**NAEGELE AWNING COMPANY, 1120 W. LINCOLN AVE, MILWAUKEE, WI 53215
 DAN 414 517 4643 OFFICE 414 645 2862 FAX 414 645 2862**

whos on third, on old world 3rd st.

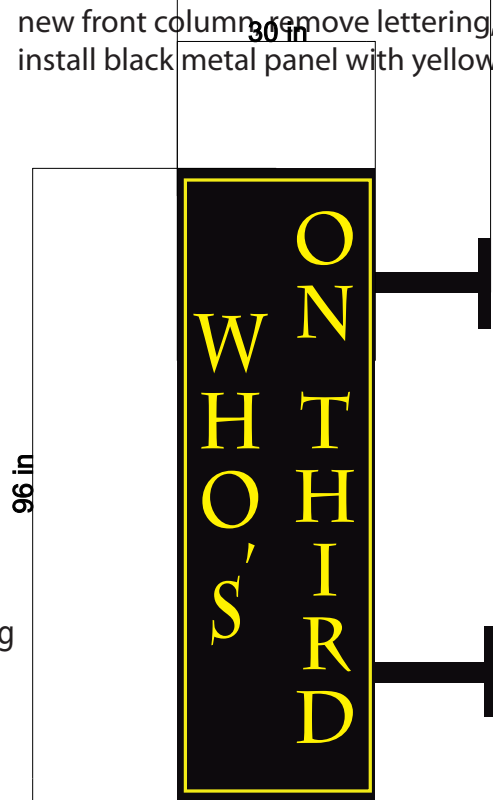
add projecting
 letters past the face

add yellow border

new front column, remove lettering,
 install black metal panel with yellow inside

change thickness on the sign
 currently at 11"
 so change to 6" thick

routed out letters, yellow tranlucent lexan projection letters
 solid black metal background
 yellow painted border 3/4" thick

-Based on engineering this is
 the minimum it should be, for
 strength on the wall and holding
 power.
